#2022-20
LES / JAIL FOOTINGS AND FOUNDATIONS
FOR
FACILITIES MANAGEMENT
ROCK COUNTY, WISCONSIN

BID PACKAGE #1 - ADDENDUM No. 1

PROJECT NAME: Rock County LES/Jail
Janesville, Wisconsin

PROJECT NUMBER: 210011.00

Sheet Number: **C1.12**

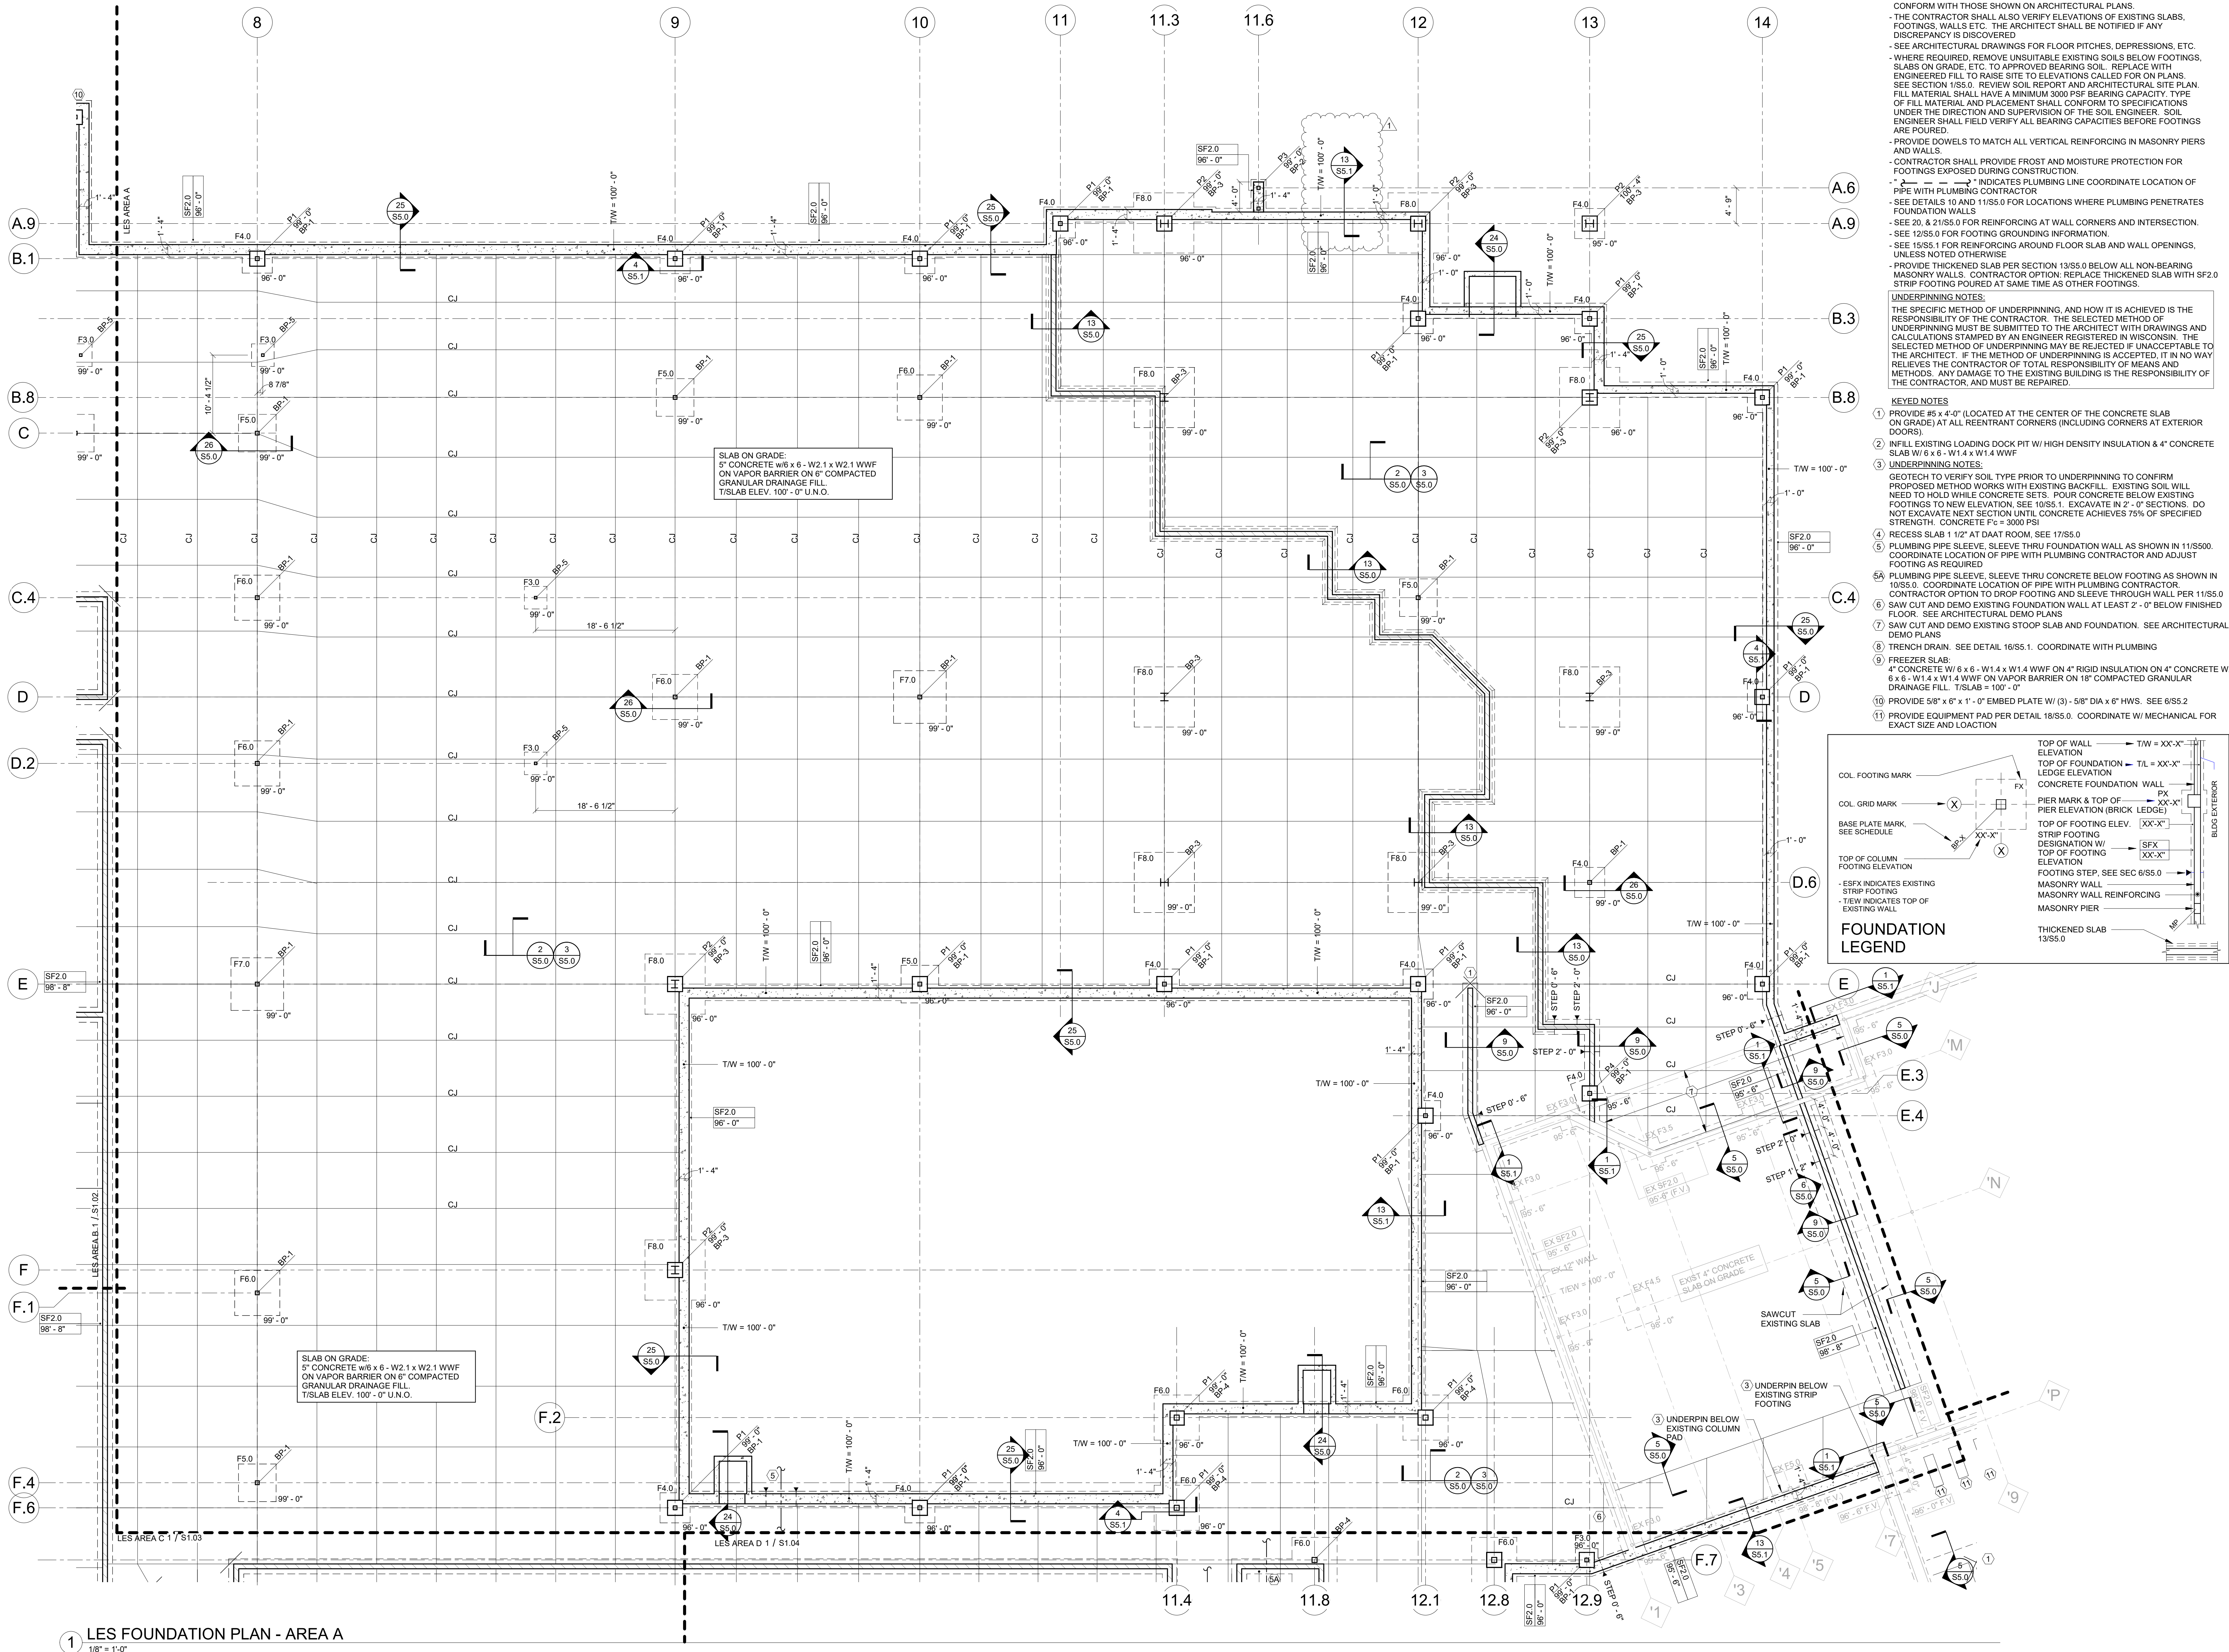
1. Sheet C1.11 Mass Grading Plan – West
 - a. ADD infiltration swales on the north side of building
2. Sheet C1.12 Mass Grading Plan – East
 - a. ADD infiltration swales on the north side of building
3. Sheet A1.03 LES Overall Floor Plan
 - a. MODIFY grids and dimensions at various locations
4. Sheet A1.04 Jail Overall Floor Plan
 - a. MODIFY dimensions at various locations
5. Sheet A1.05 Jail Overall Second Floor Plan

Sheet Number: **S1.01**

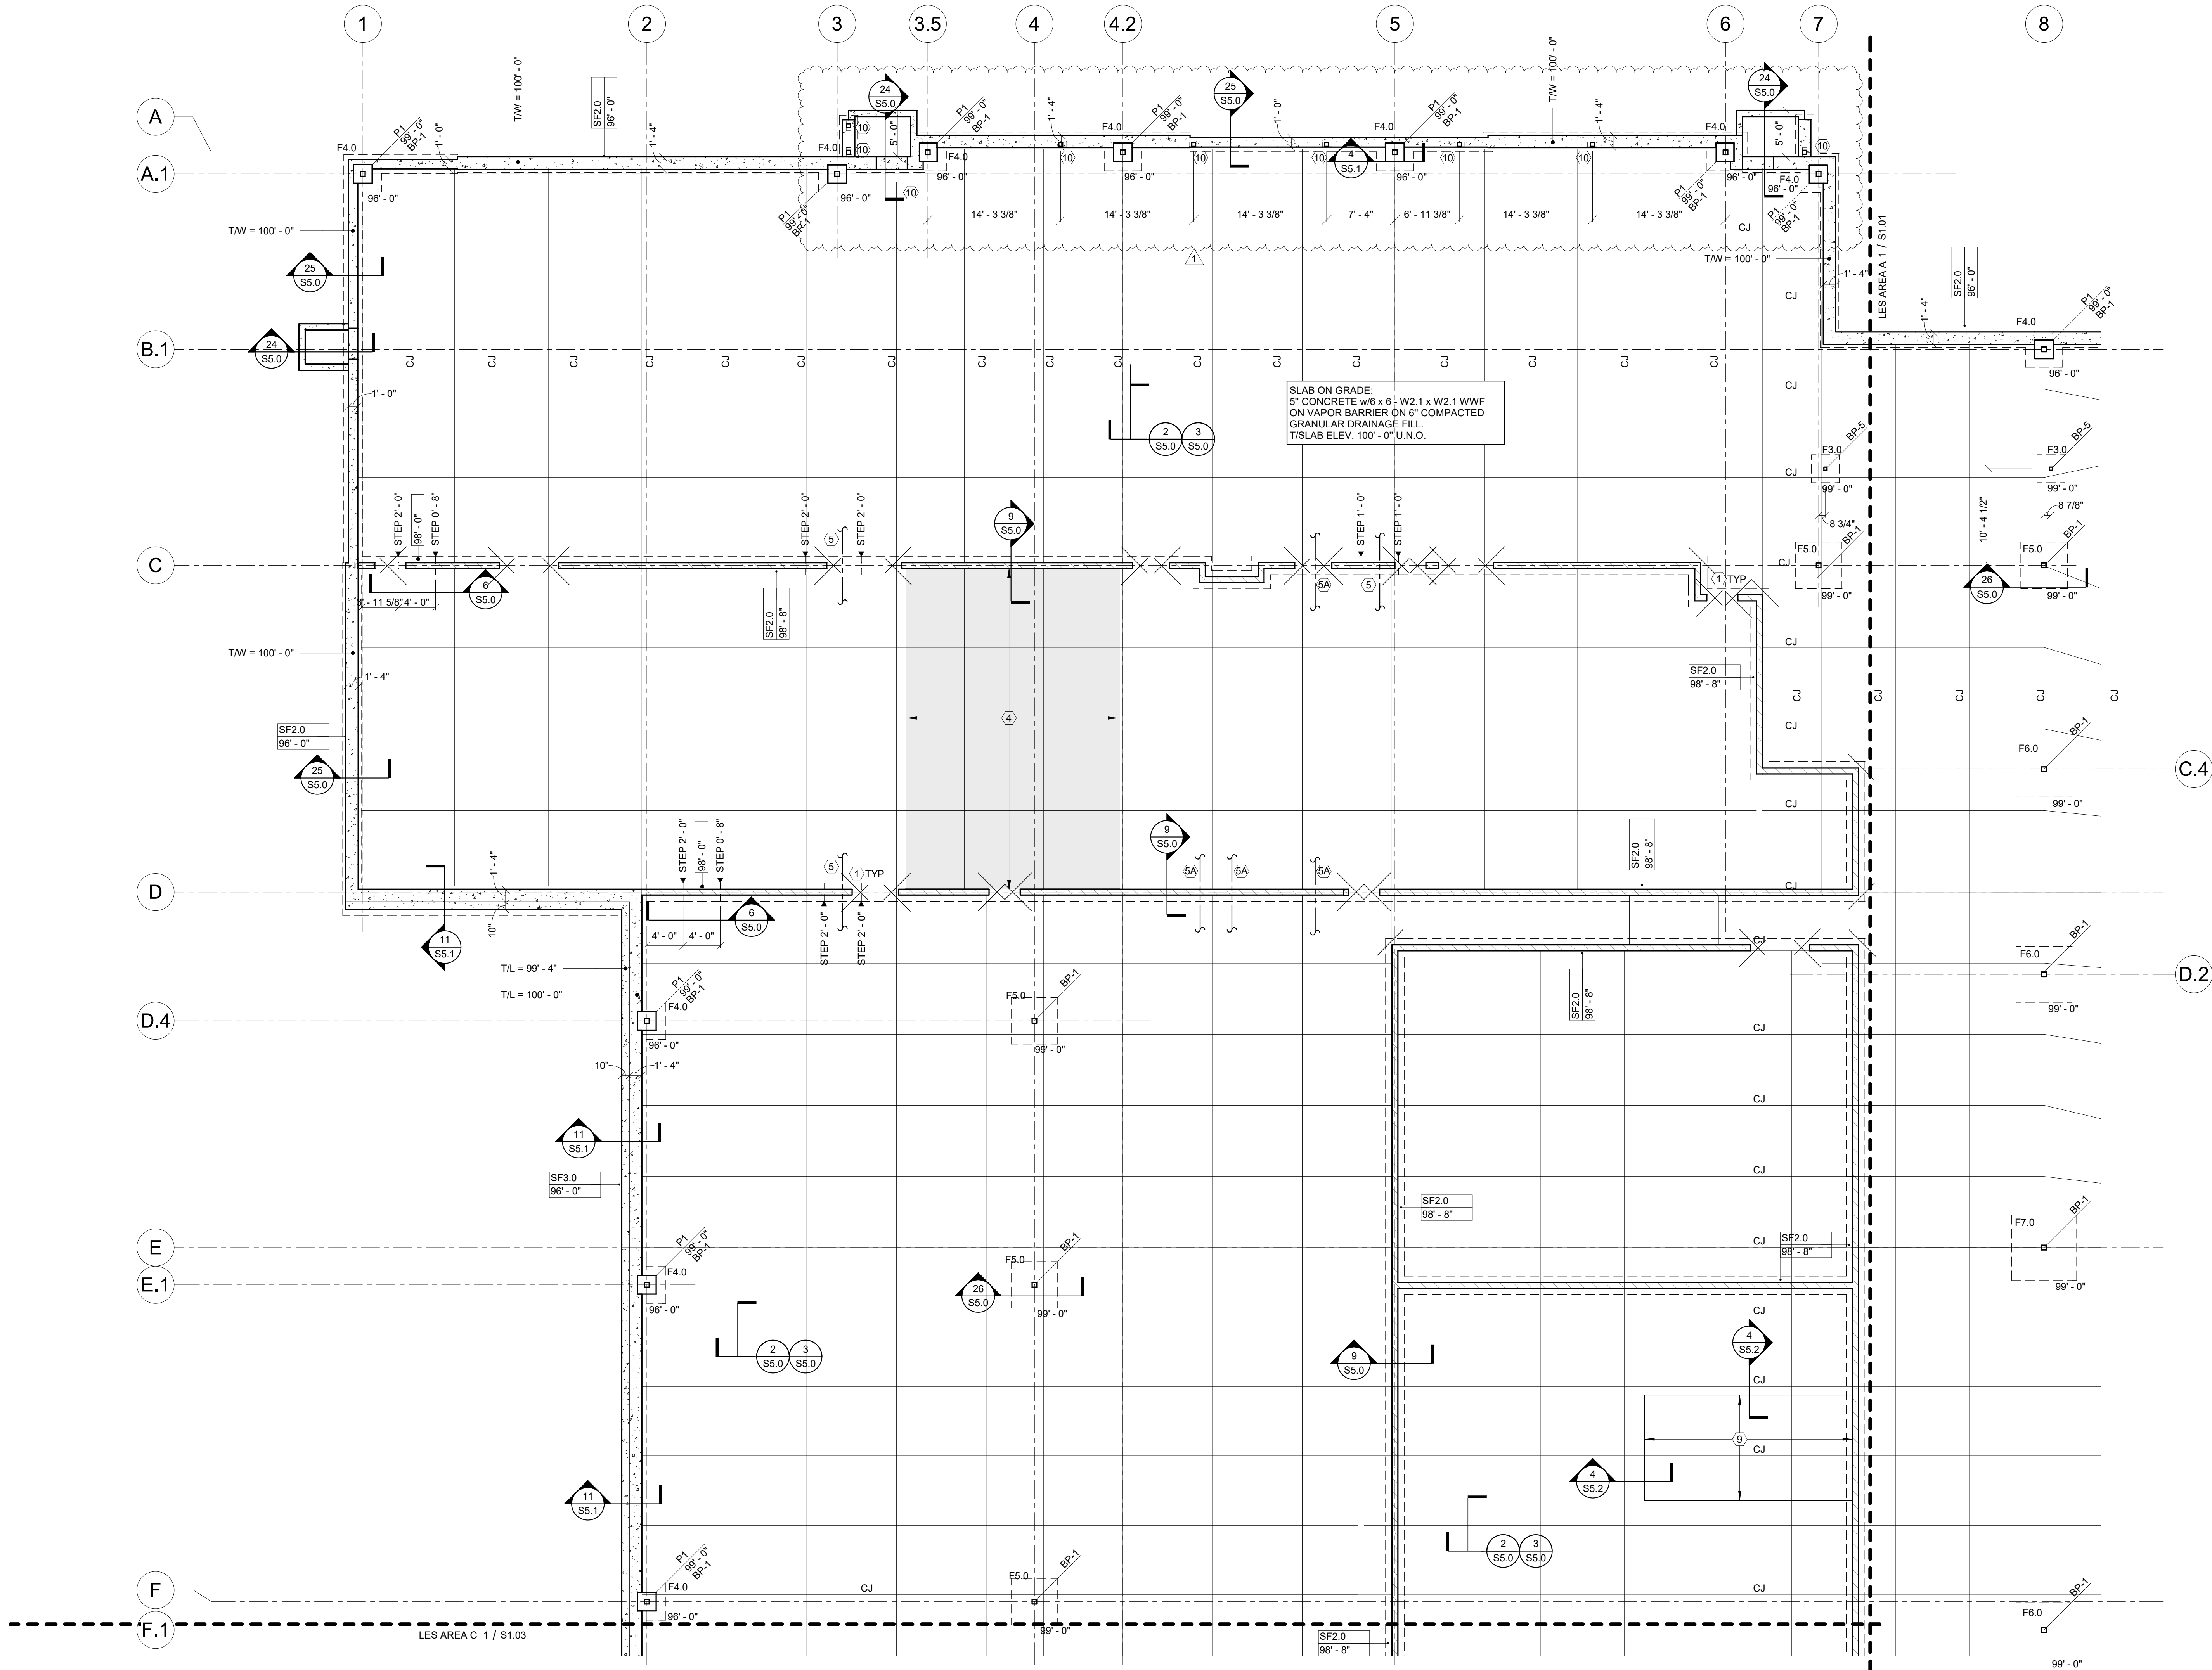
- a. MODIFY dimensions at various locations
- 6. Sheet S1.01 LES Foundation Plan – Area A
 - a. ADD detail 13/S5.1 at A.9 between 11.5 and 12
 - b. MODIFY top of foundation wall at A.9 between 11.5 and 12

- c. MODIFY various exterior foundation wall thicknesses
- 7. Sheet S1.02 LES Foundation Plan – Area B
 - a. MODIFY various exterior foundation wall thicknesses

Graphic Scale
Project Number: 210011.00
Set Type: CD
Date Issued: 3/22/2022
Sheet Number: **S1.02**

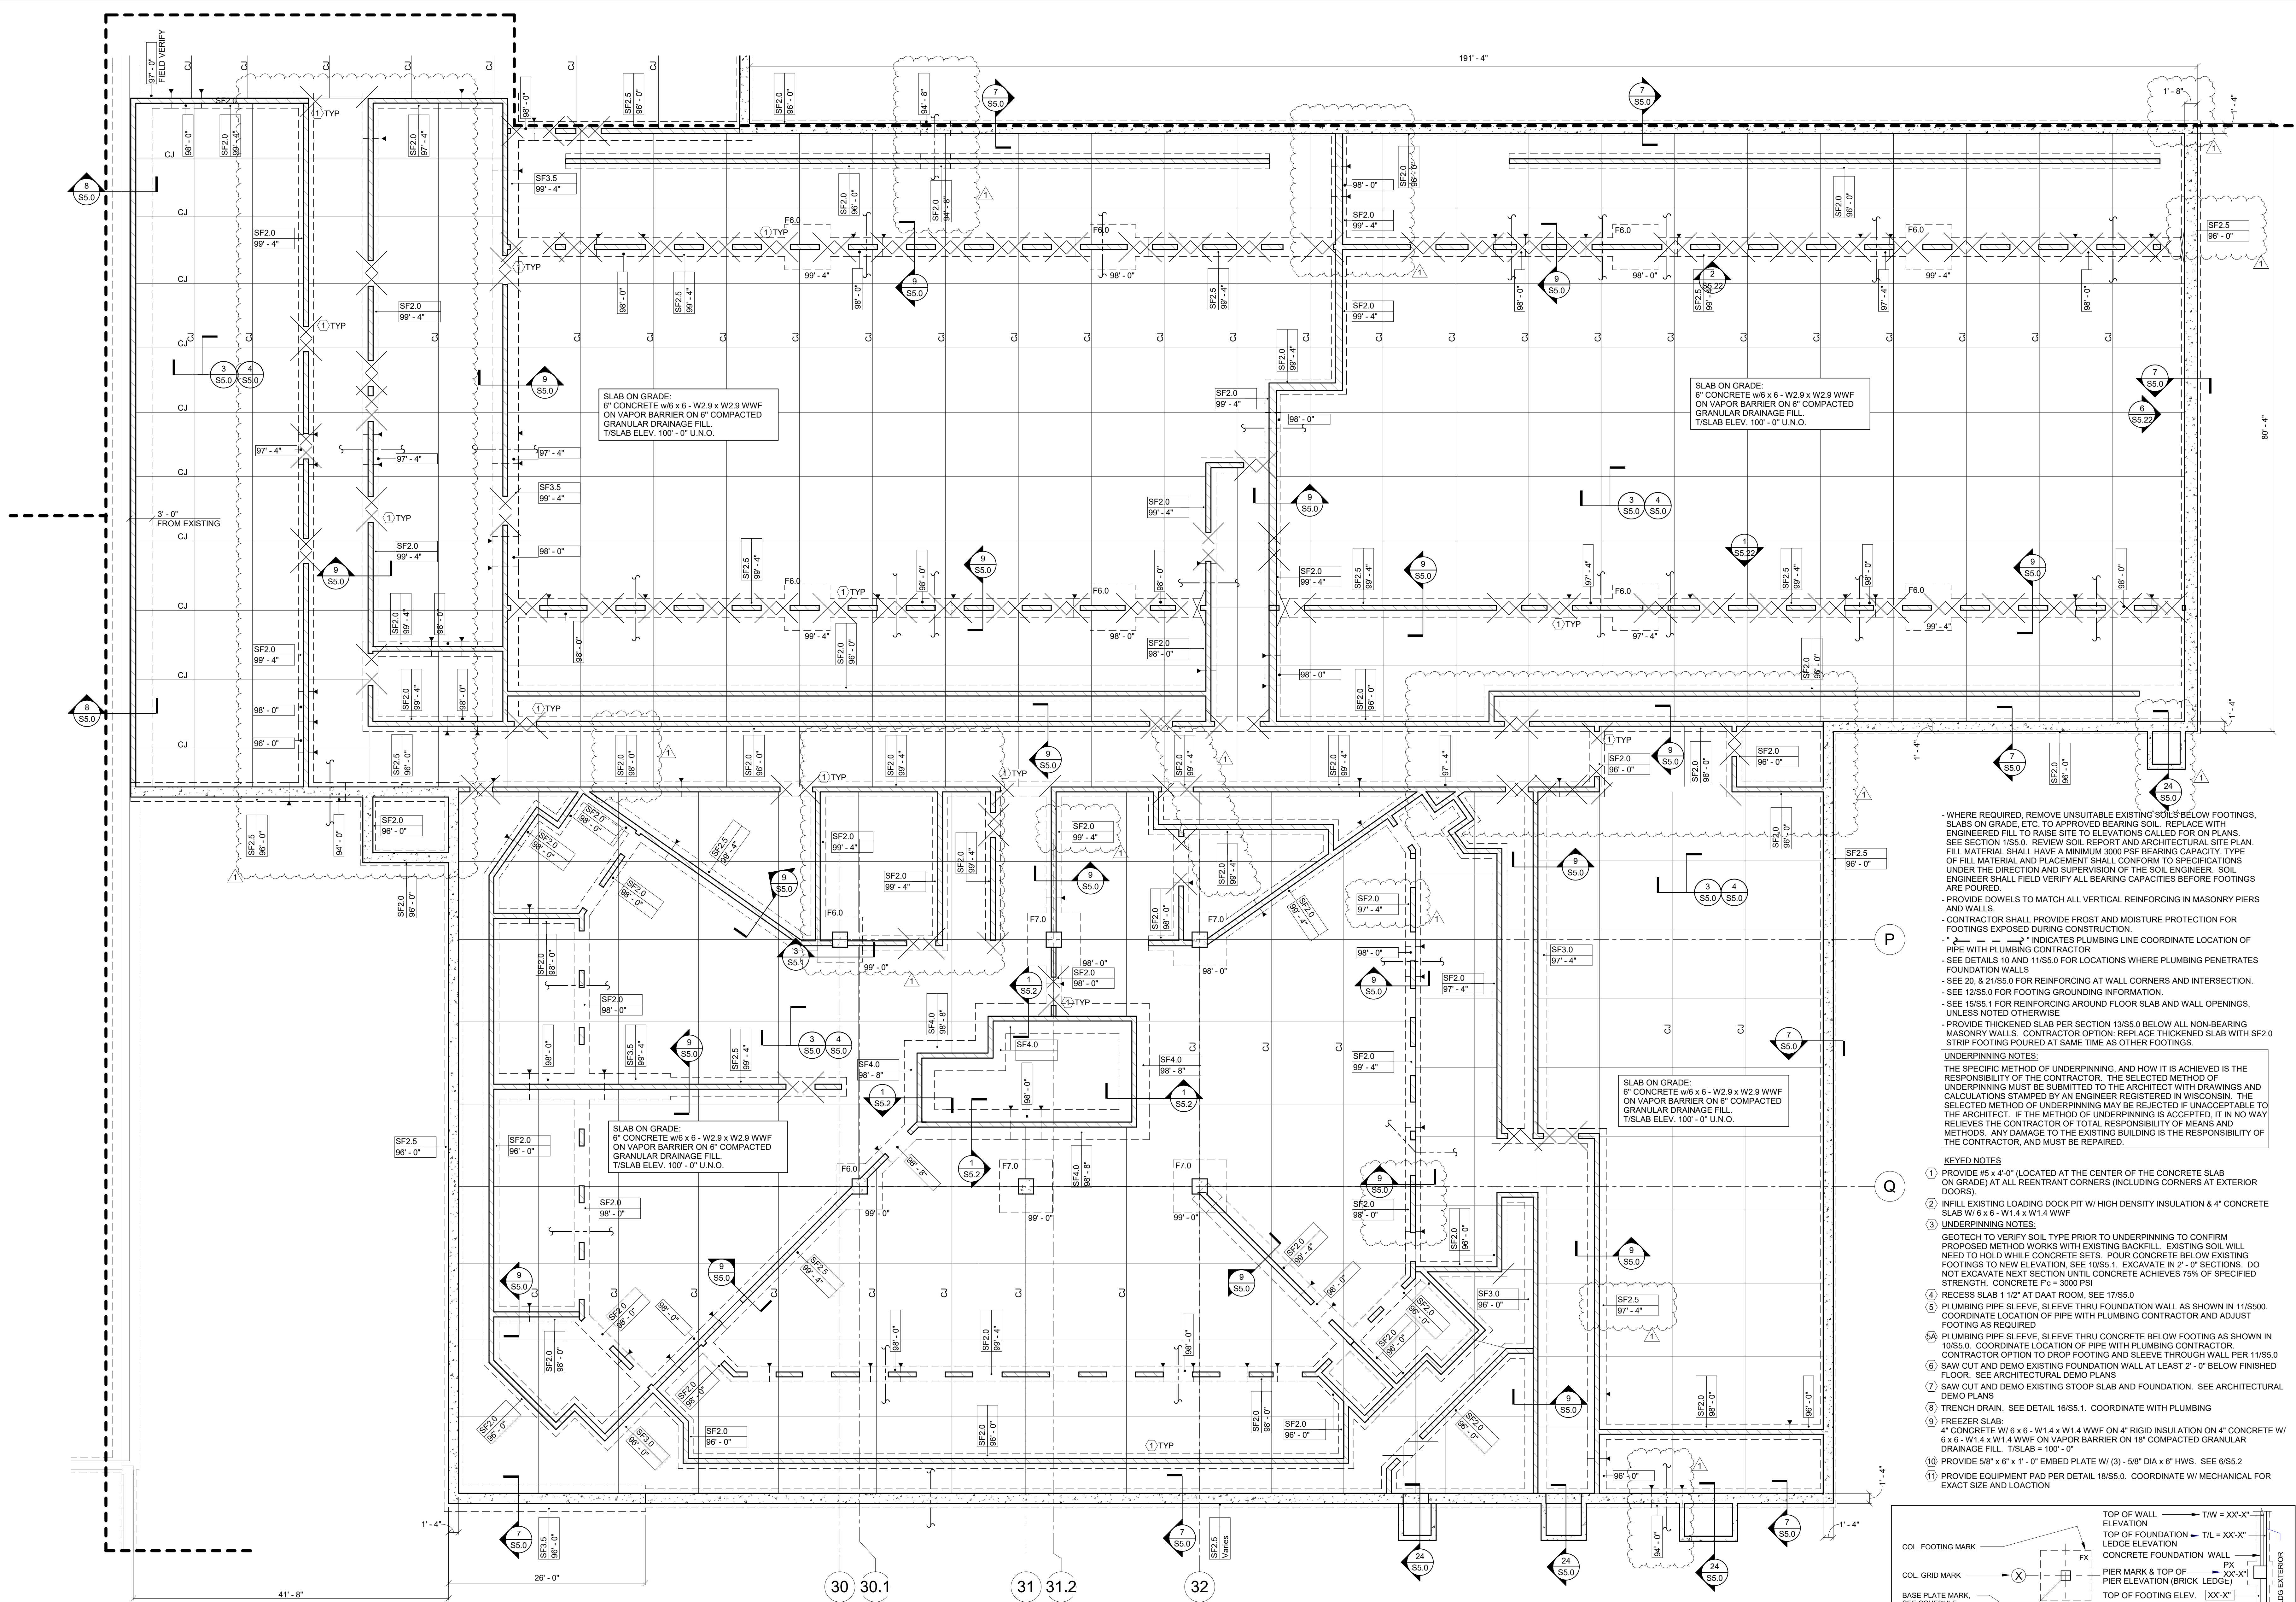
- b. ADD embed plates (keyed note 10) along A between 3 and 7
- 8. Sheet S1.12 Jail Foundation Plan – Area F
 - a. ADD footings to several areas
 - b. ADD / MODIFY footing elevations and steps at various locations
